SHOREHAM NUCLEAR POWER STATION

SNRC-605

SHOREHAM NUCLEAR POWER STATION - Unit 1  
Docket No. 50-322

LILCO RESPONSE TO NRC AUDIT FINDINGS  
SHOREHAM NUCLEAR POWER STATION - UNIT 1

Div. II Section of H11-P601

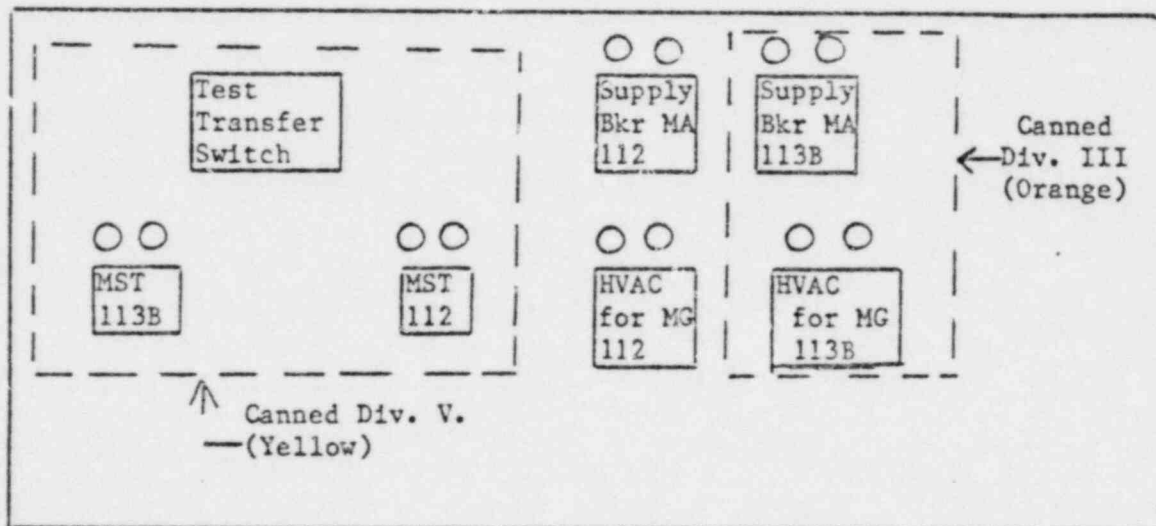
Transfer switch MST 113B and related switch MG 113B are separated by switch 112 and a breaker. Similar arrangements are found for switch 111 and switches 113A. (2)

The layout was designed for electrical separation. See diagram below:

LILCO will reverse switches MST 112 and 113B and provide color pad enhancement for the entire switch cluster diagramed above. A similar change will be accomplished for Division I switches on panel 601. This will be accomplished prior to fuel load.

SHOREHAM ADS SYSTEM COLOR PADDING

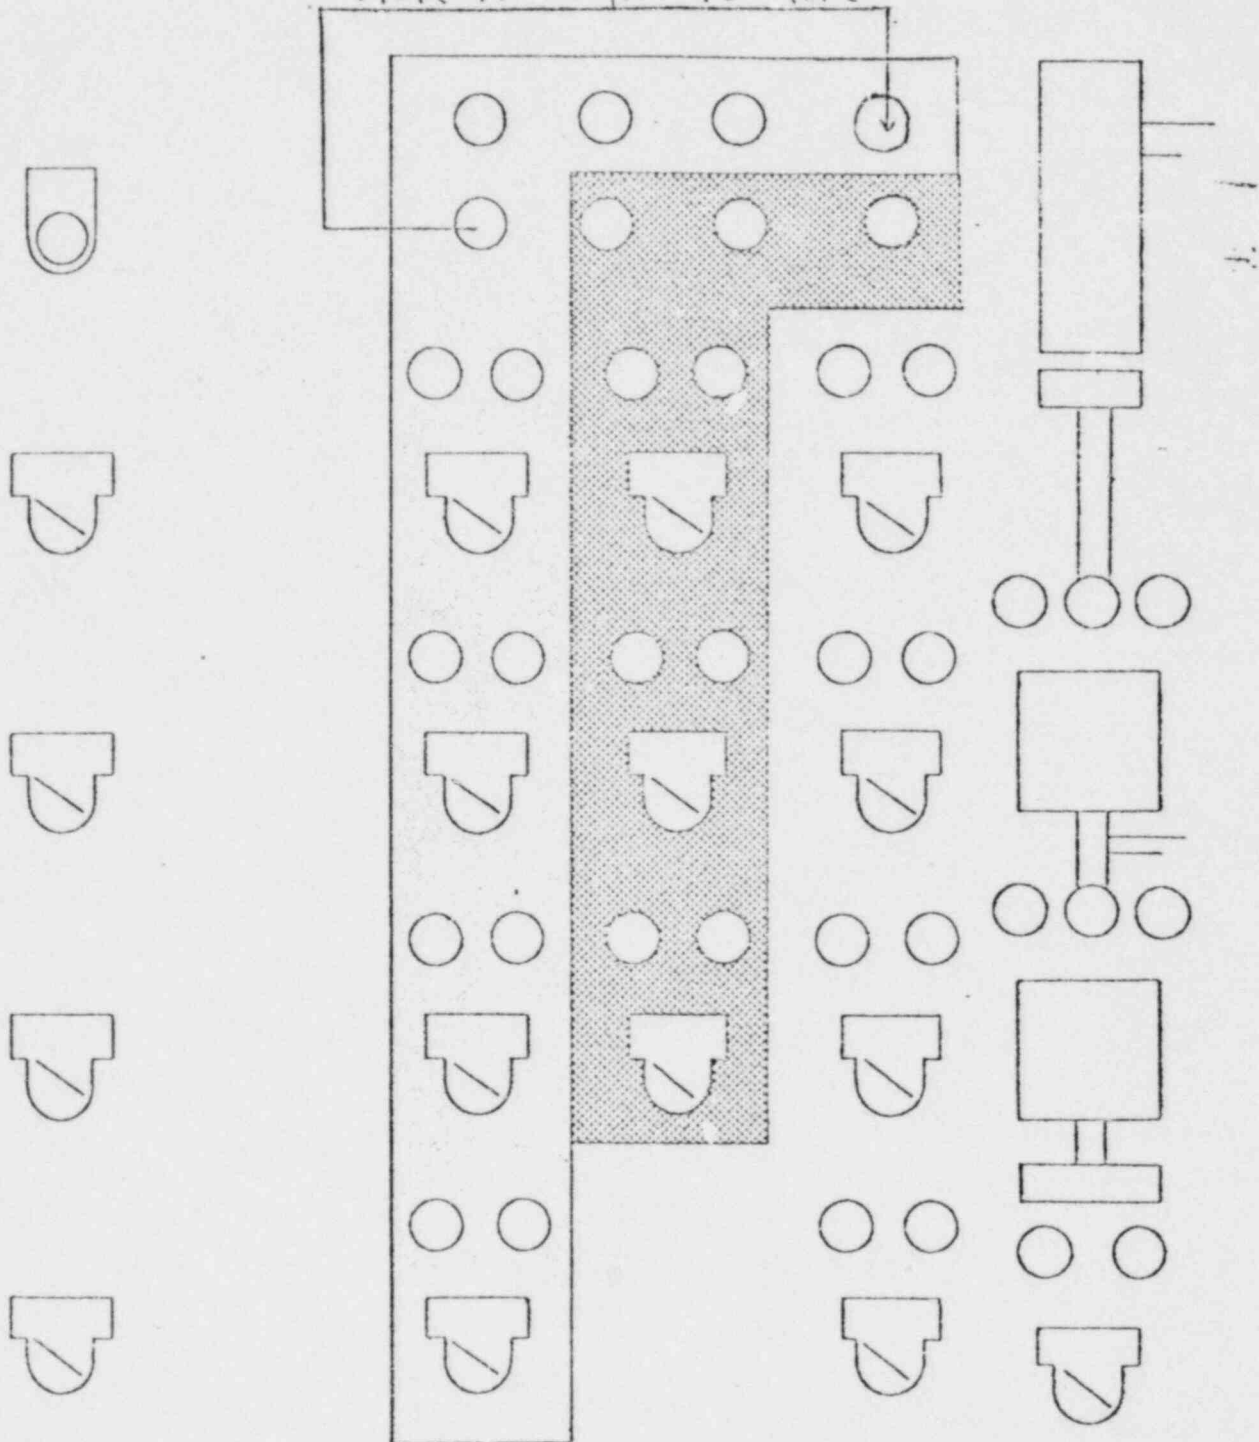
On Panel 602 there is an inconsistent relationship among the valve switches and the corresponding indicator lights in both position and orientation. (1) (9.1)

The NRC finding is concerned with the relationship of the switches associated with the ADS and Safety Relief Valves and the corresponding indicator lights. LILCO has identified this problem in their preliminary assessment report as item 9.1. The ADS system will be enhanced through color padding to improve the switch/indication relationship (see enclosure 2). The B solenoid red indicating light for the SRV "H" will be relocated as shown on enclosure 2. This will be accomplished prior to fuel load.

Move "H" light to here
